CHANGE LIST

PROJECT : JR8

Size	Document Number	Rev
	LED BOARD	3A
Date:	Friday, December 03, 2010	Sheet 1 of 1

LED (UIF)

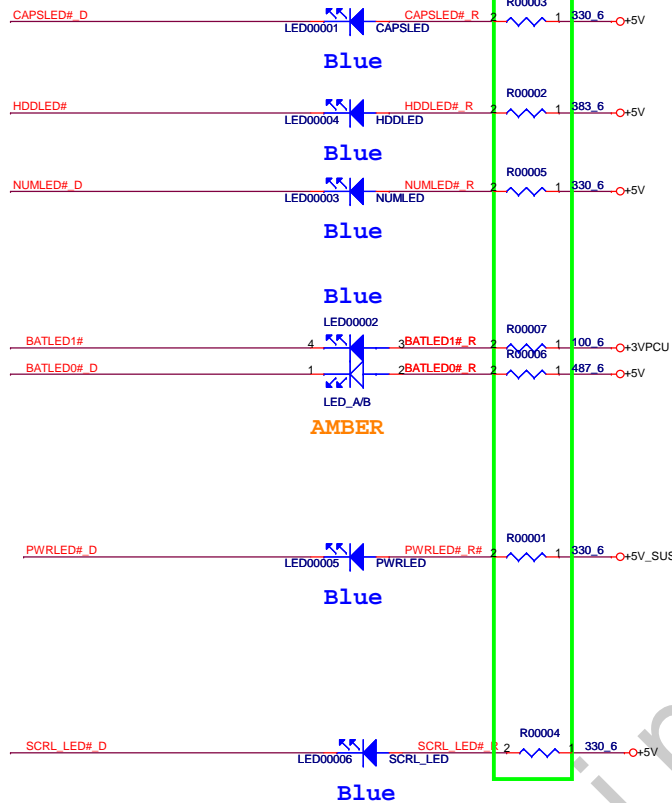
11/16: C Stage
Resistor-->From 220ohm to 330ohm
Resistor-->R00007 from 1.5k to 100ohm, R00006 from 1.5k to 487ohm

R00001/4/3/2/5-->From 220ohm to 330ohm.
R00007 from 1.5k to 100ohm,R00006 from 1.5k to 487ohm

Connector (UIF)

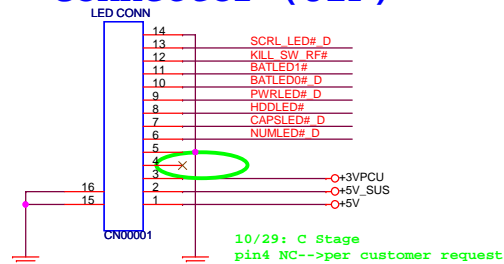
10/29: C Stage
pin4 NC-->per customer request

CN00001 pin4 NC-->per customer request
